RE: Smiles for Kids Dental Office – Phase 2
Conceptual Grading and Drainage Plan
Stamp Date: 6/7/17
Hydrology File: C12D055

RE: Smiles for Kids Dental Office – Phase 2
Conceptual Grading and Drainage Plan
Stamp Date: 4/26/17
Hydrology File: C12D055

project title	Smiles for Kids Dental Office PHASE 2
sheet title	Conceptual Grading & Drainage Plans

sheet-
C100

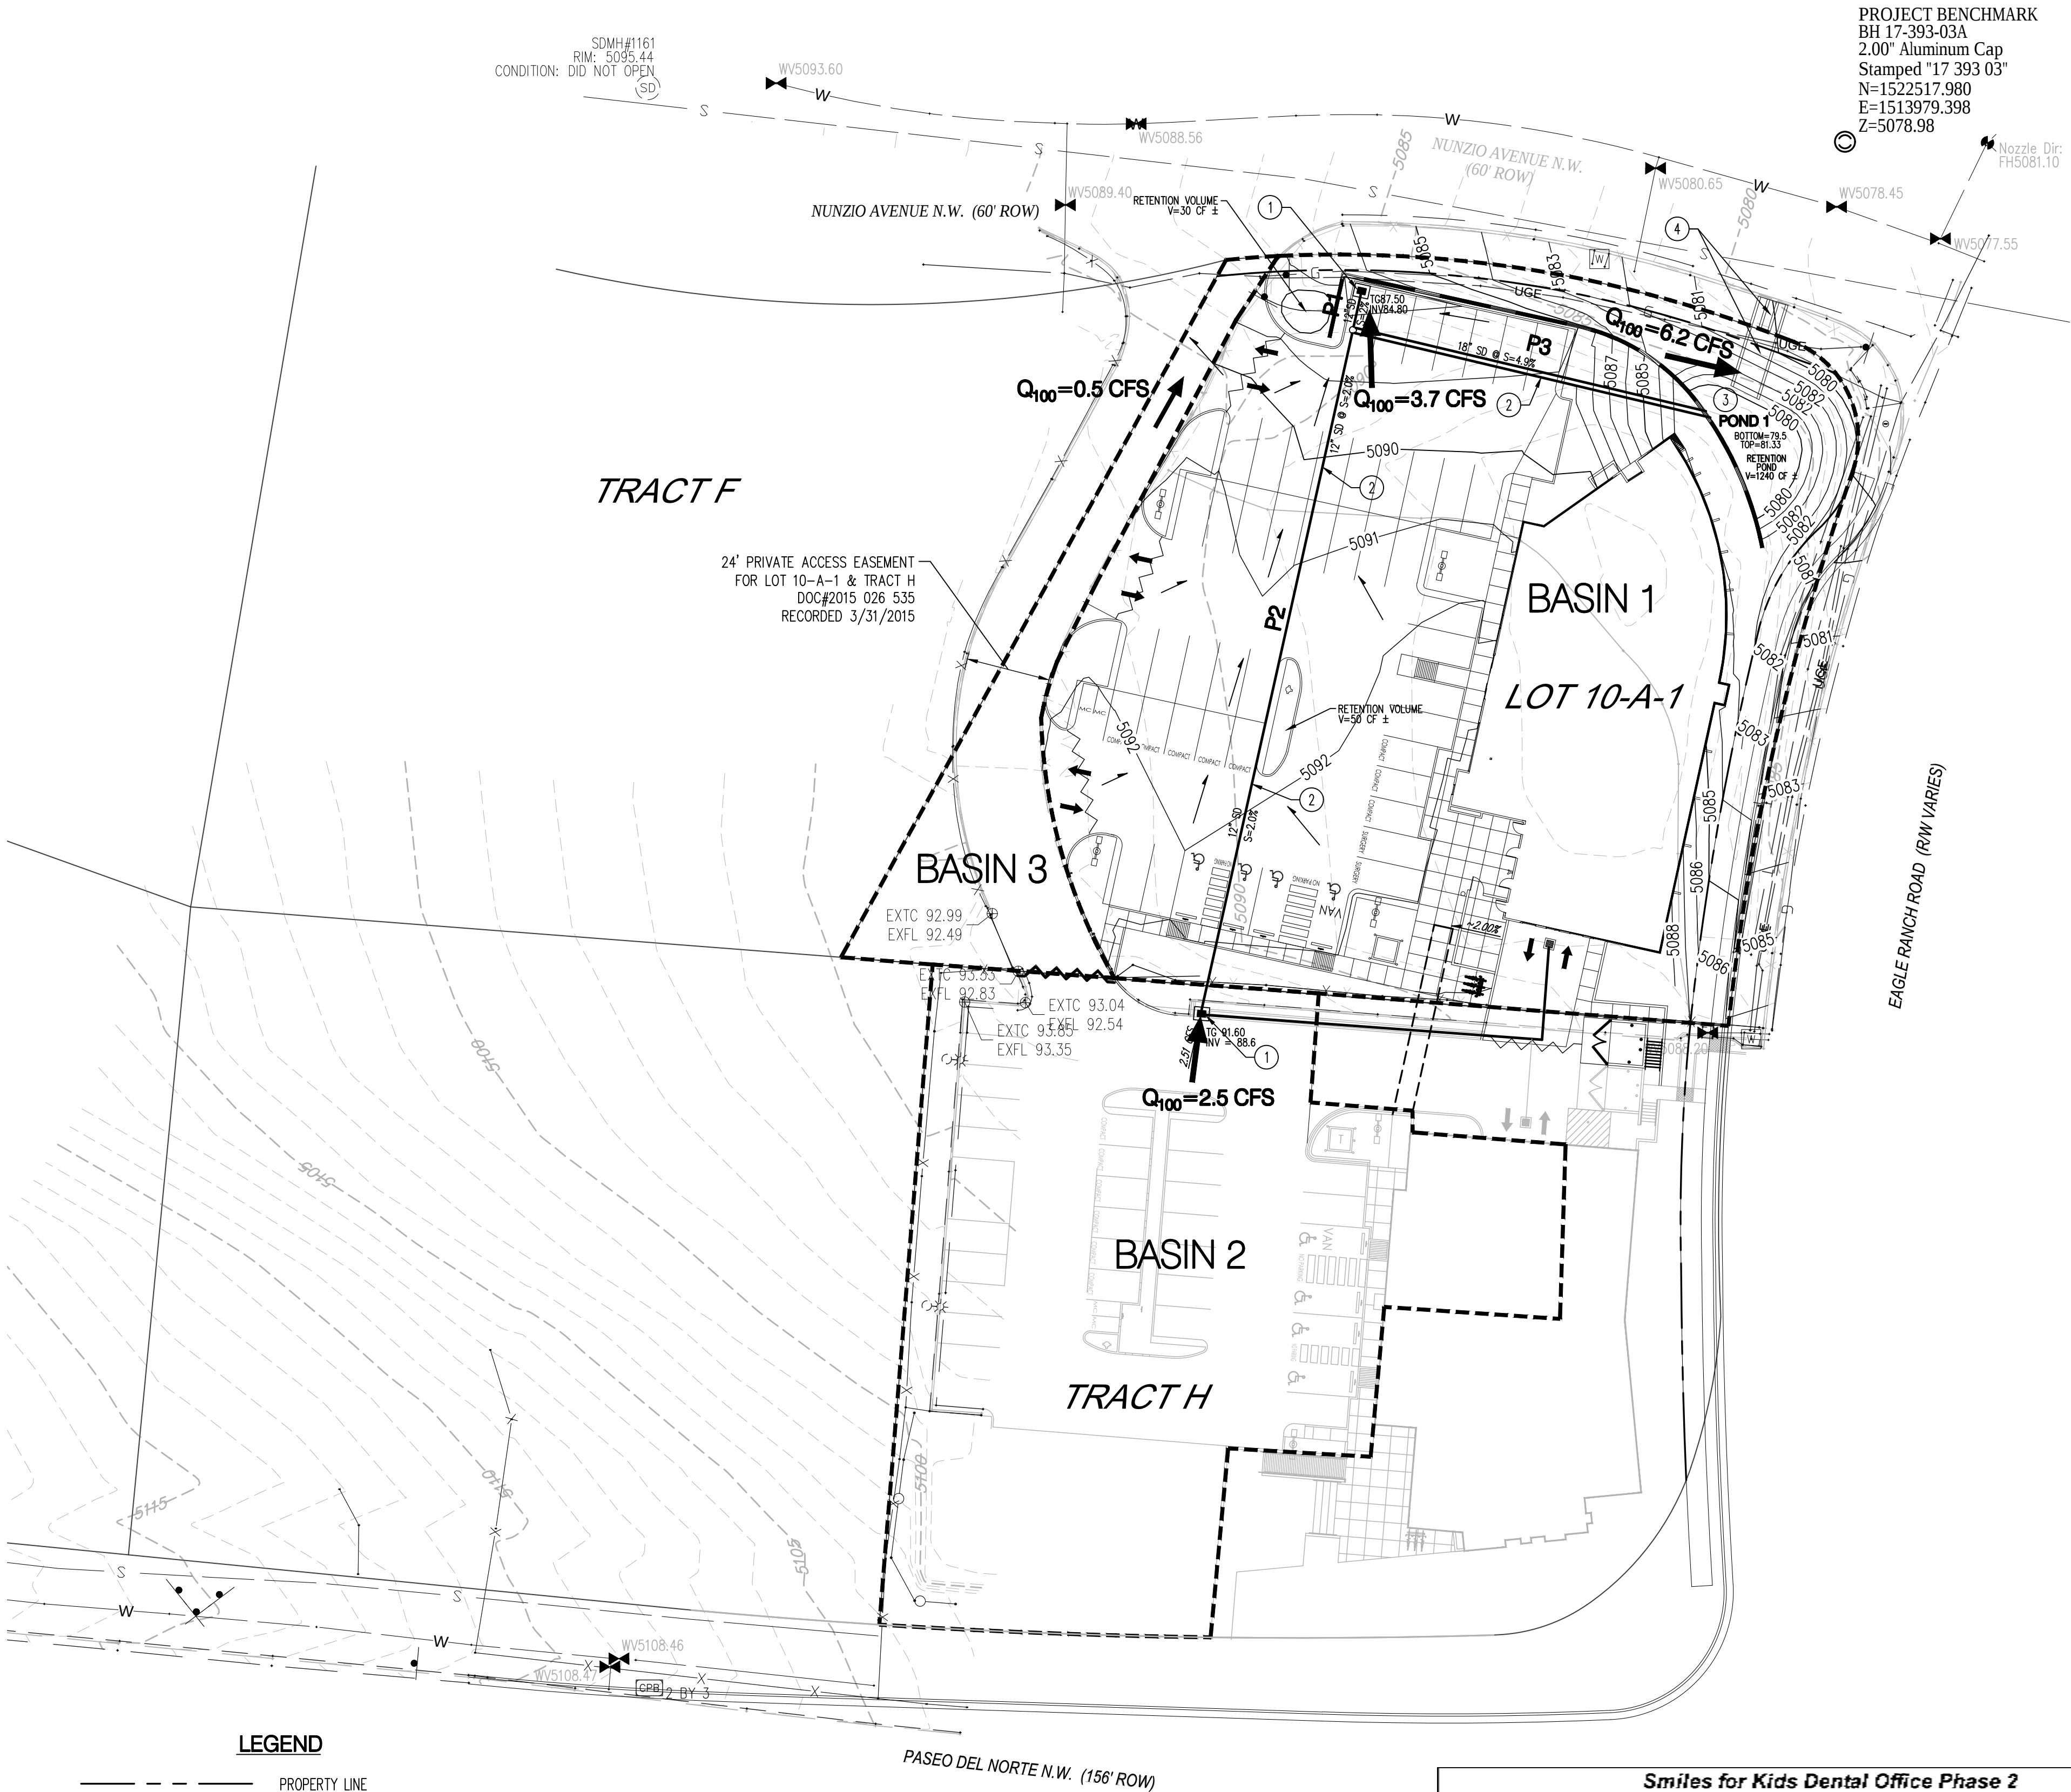
12. On Sheet C100. Please provide the existing TC & FL at the corners of the Phase 1 parking lot in a 70 foot radius around the proposed inlet. I would like to insure the drainage pattern for the proposed inlet.

13. On Sheet C100. Along the existing access drive, please provide the existing TC & FL at the proposed curb return for the parking lot entrances.
14. On Sheet C100. There is an existing inlet for the Phase 1 underground parking. This inlet has a sump pump and a pvc discharge pipe that goes into the existing concrete rundown. See photo below. The Phase 2 plan does not show that there is a connection to the proposed storm sewer system. Please provide the connection.

15. On Sheet C100. The Phase 2 underground parking has a proposed inlet without a connection to the proposed storm sewer system. Please provide the connection.

17. On Sheet C100. Lot 10 A-1 and Tracts G & H are not included in the Fountain Hill financial deferment of the sidewalks. Therefore please show the sidewalk along Nuzio Avenue and Eagle Ranch Road.

12. Top of curb and flow line elevations have been added.
13. Top of curb and flow line elevations have been added.

14. The Phase 1 storm drain sump pump discharge line connection has been added. This discharge line will connect to a new inlet on Tract H.
15. The Phase 2 storm drain sump pump discharge line connection has been added. This discharge line will connect to the Phase 1 line and new inlet on Tract H.

16. The cross sections along Nunzio and Eagle Ranch have been added.
17. The paved asphalt trail along Nunzio and concrete sidewalk along Eagle Ranch have been added.

SECTION A - EAGLE RANCH ROAD - PROPOSED CROSS SECTION
NTS

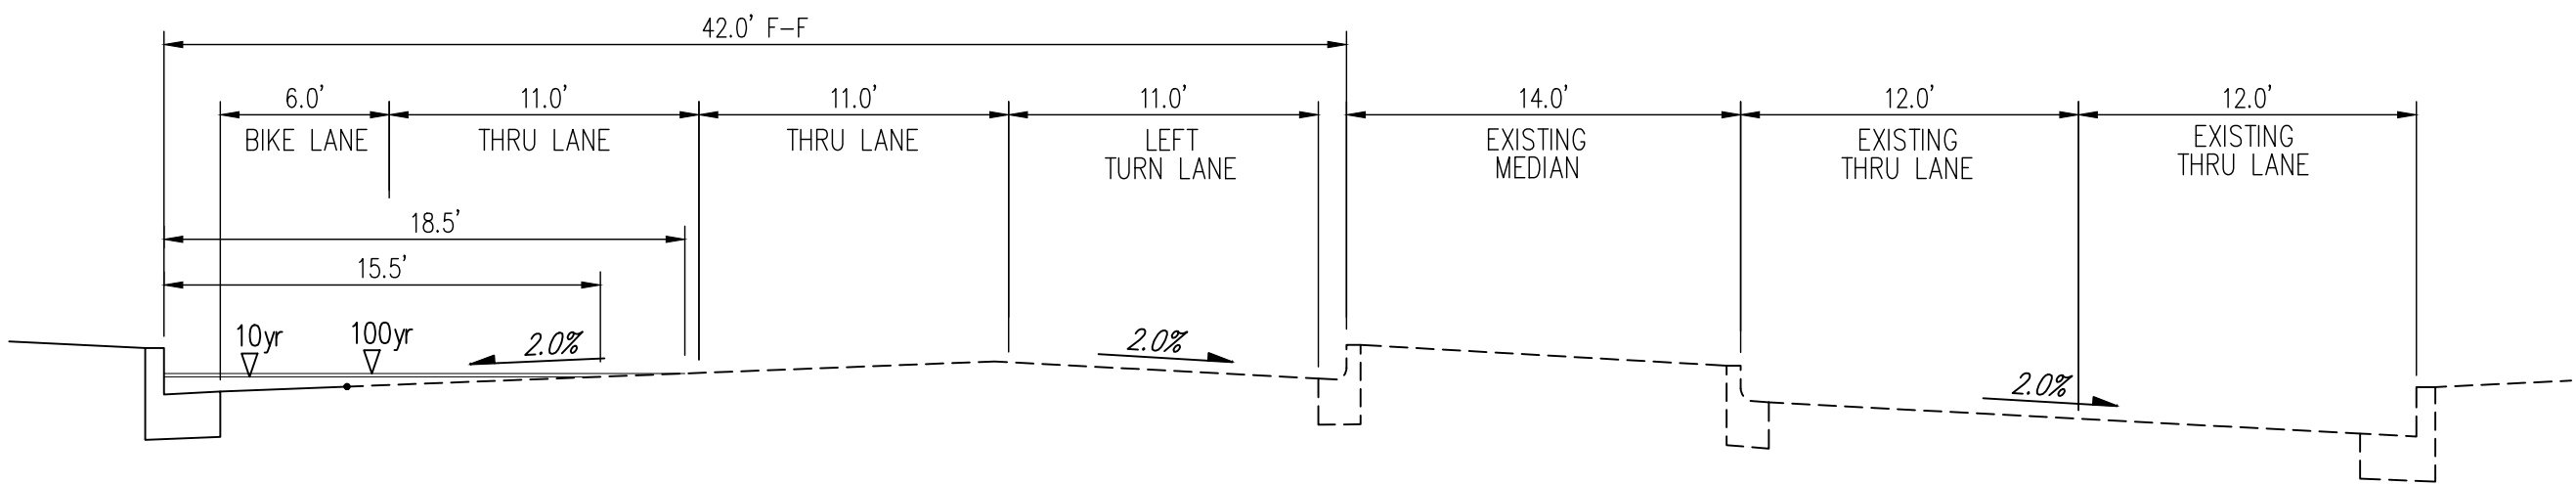
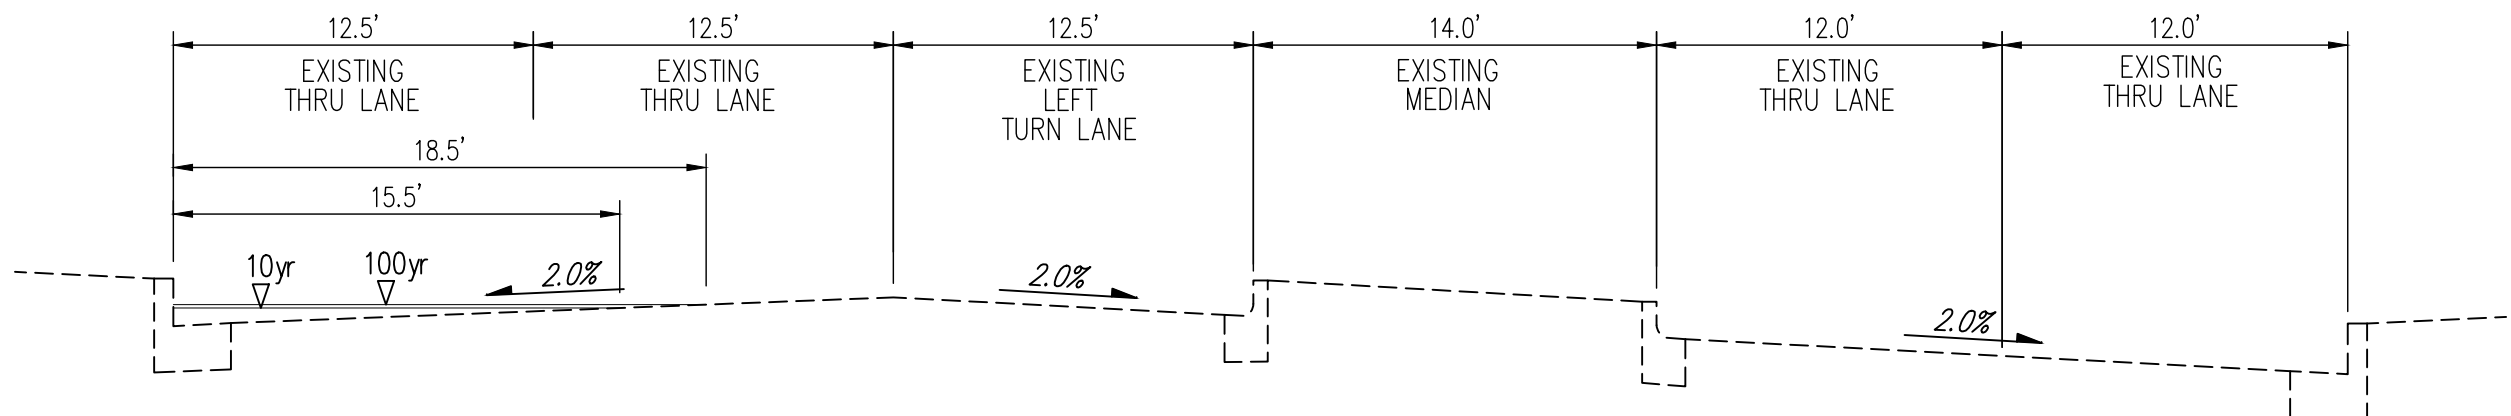
16. On Sheet C100. Please provide two cross sections of the proposed retention pond. One along Eagle Ranch Road and the other at the proposed sidewalk culverts on Nunzio Avenue.

EAGLE RANCH ROAD - SECTION C
NTS

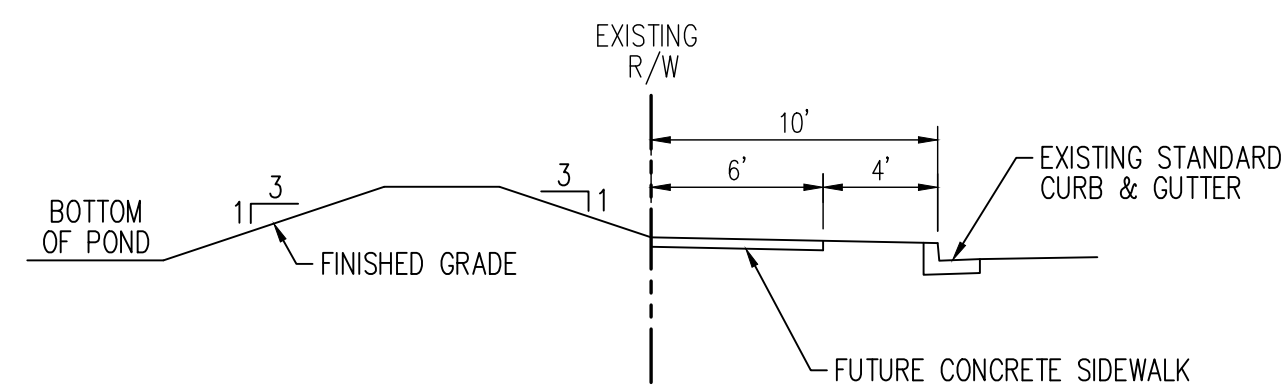
20. Please show the capacity calculations on Eagle Ranch Road right below the pond's outfall for the 10 year and 100 year storm event.

20. Sheet C-002, Eagle Ranch Capacity Calculations have been added to the submittal package.

THE CAPACITY OF EAGLE RANCH WAS CALCULATED USING MANNINGS EQUATION. IN THE 10 YEAR STORM THE DEPTH OF FLOW IS 0.4 FEET AND SPREAD IS 18.5 FEET. THE SPREAD IN THE 10 YEAR STORM ENDOACHES INTO THE SECOND THROUGH LANE BY APPROXIMATELY 4 FEET. THIS TECHNICALLY DOES NOT MEET THE CRITERIA SPECIFIED IN THE DPM, BUT LEAVES A 6.5 FOOT DRIVING LANE. THE DEPTH OF FLOW IN THE 100 YEAR STORM IS 0.46 FEET AND IS CONTAINED WITHIN THE ROADWAY.
